**STAFF REPORT
FOR THE PLANNING COMMISSION**

FILE NUMBER: VAR-23-01

REQUEST: Class II variance to allow more than 4 lots (six total) to be served from a private driveway on Marylhurst Drive, approximately midblock between Upper and Lower Midhill Circle.

PRIVATE ALLEY PLAN AND PROFILE
MARYLHURST SUBDIVISION
 WEST LINN, OR

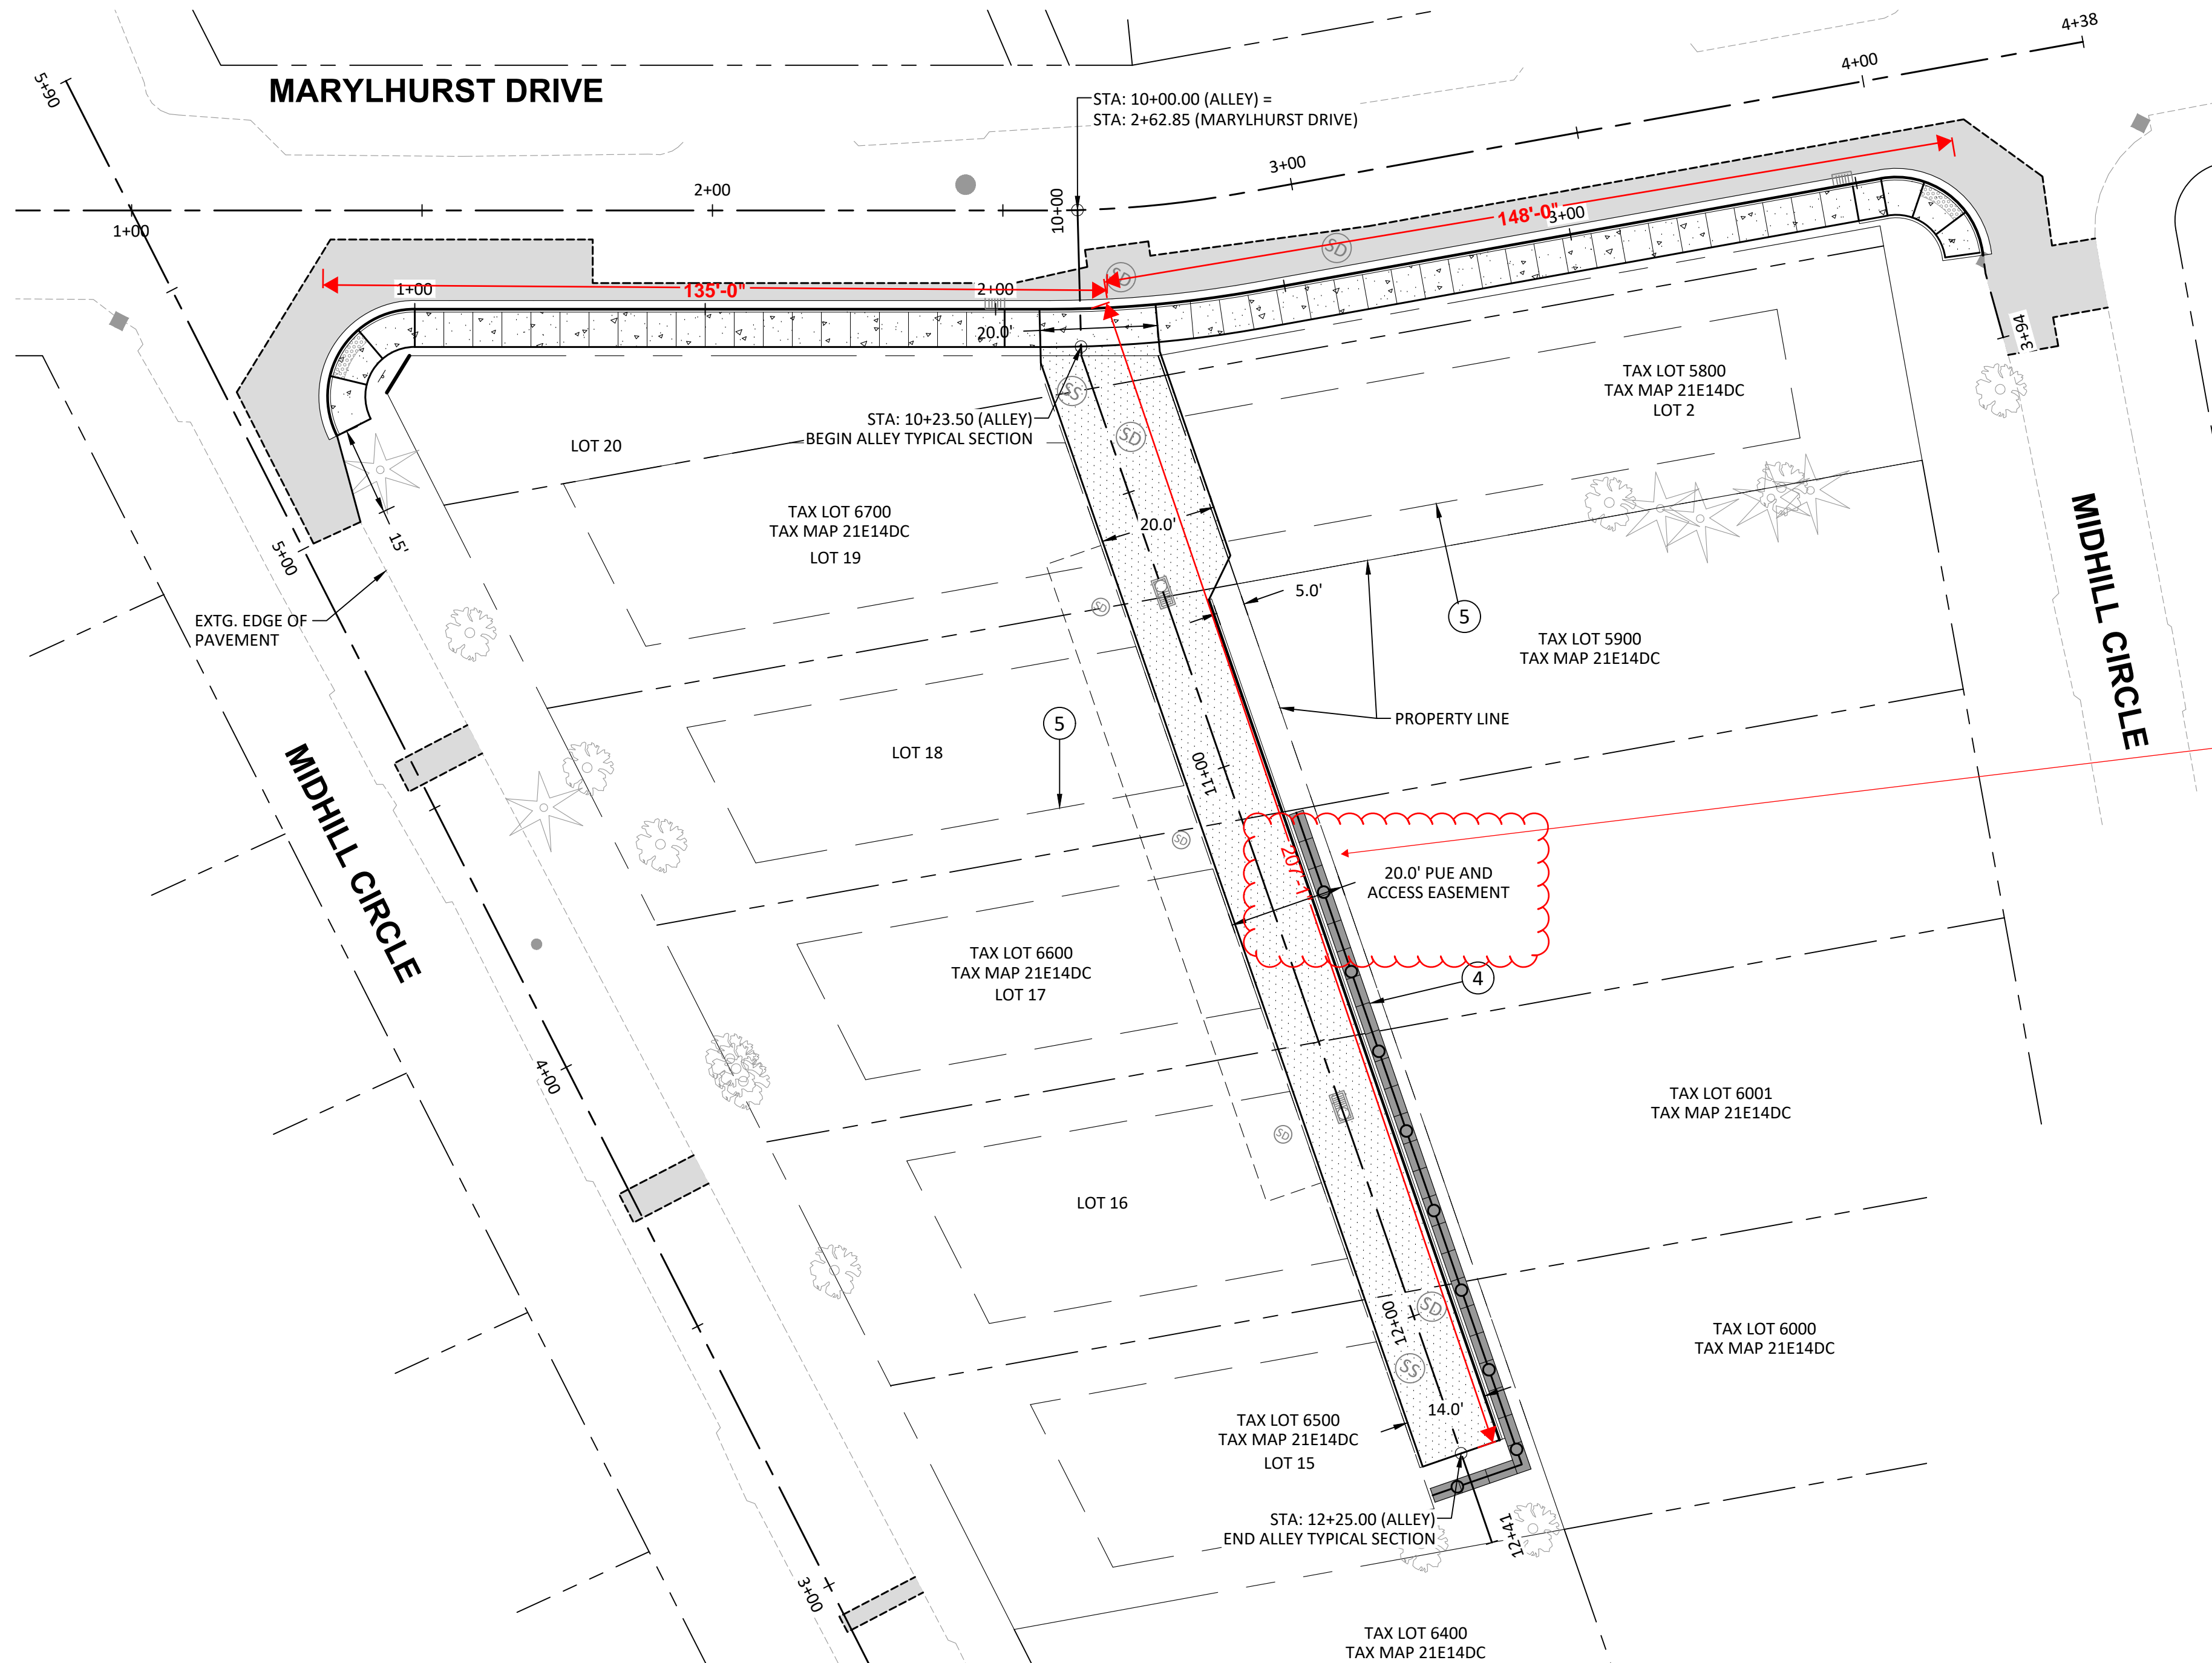
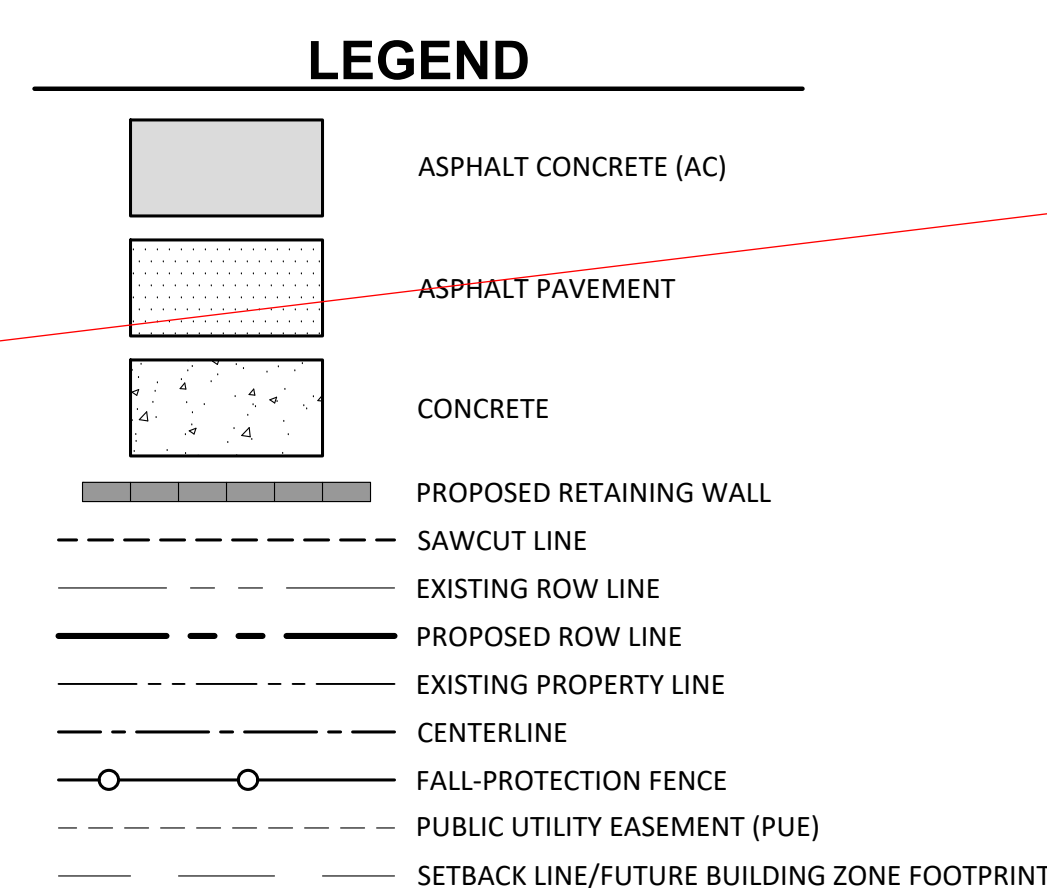
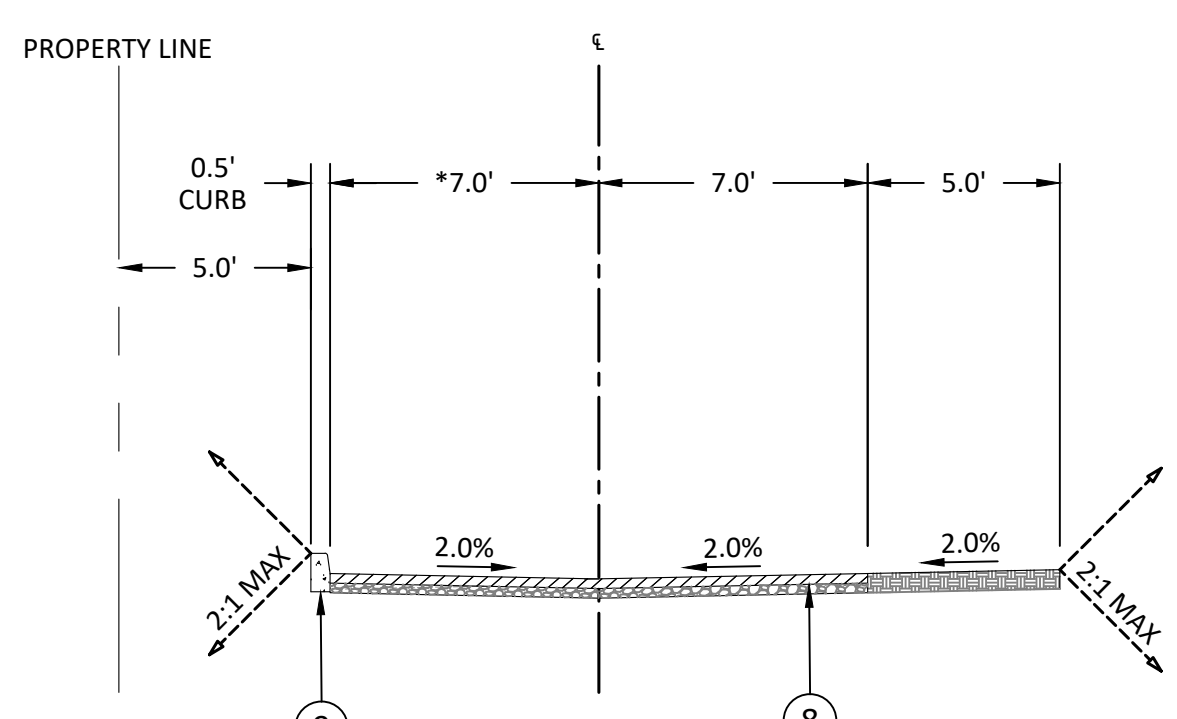
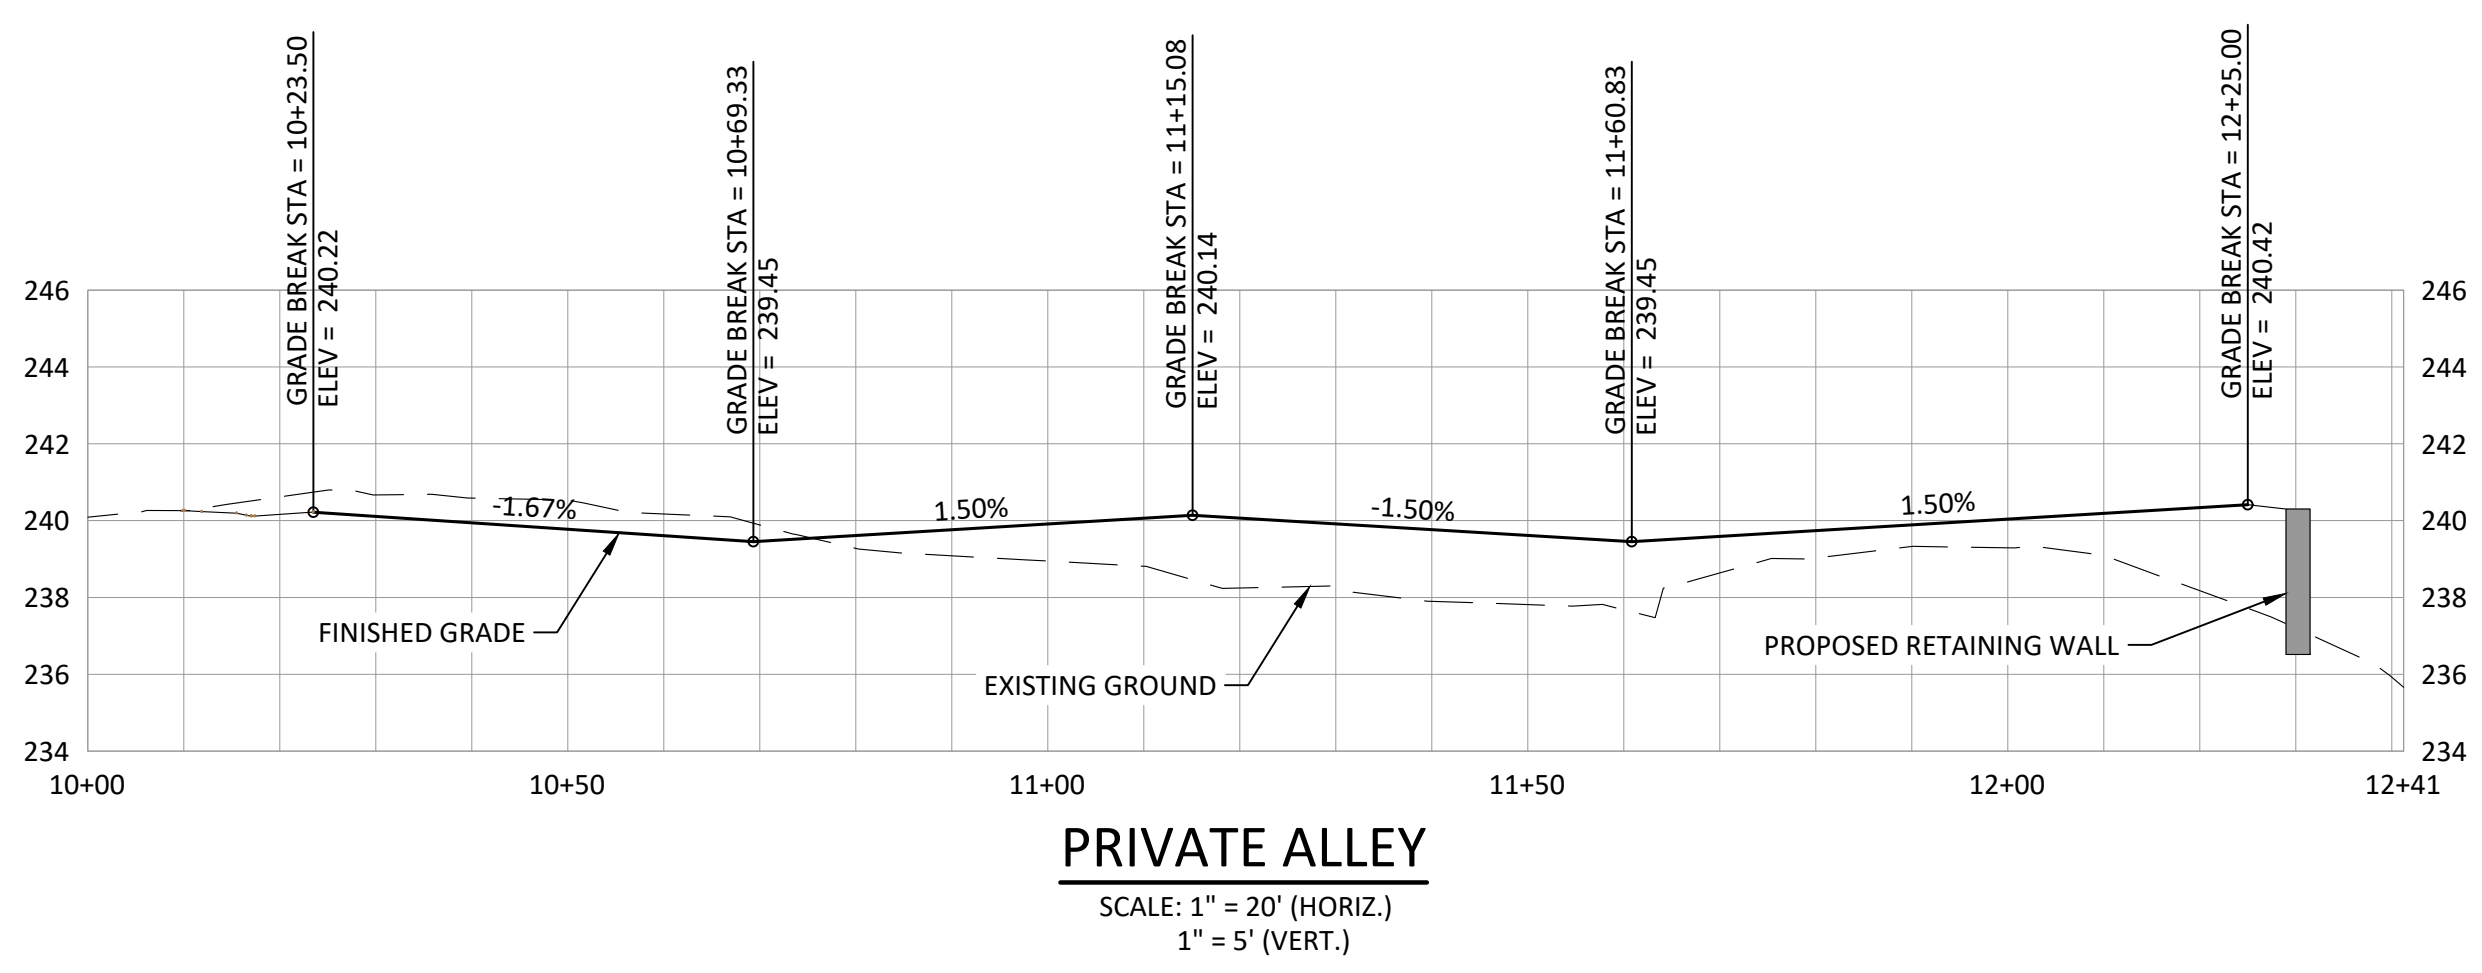
FIRE ACCESS is within TVF&R'S 200' allowance as per fire code exception 1.3 OFC 503.1.1 for 1 & 2 family residences.

NO PARKING fire lane signs required along private road. 20' minimum road width OFC D103.6.1-2.
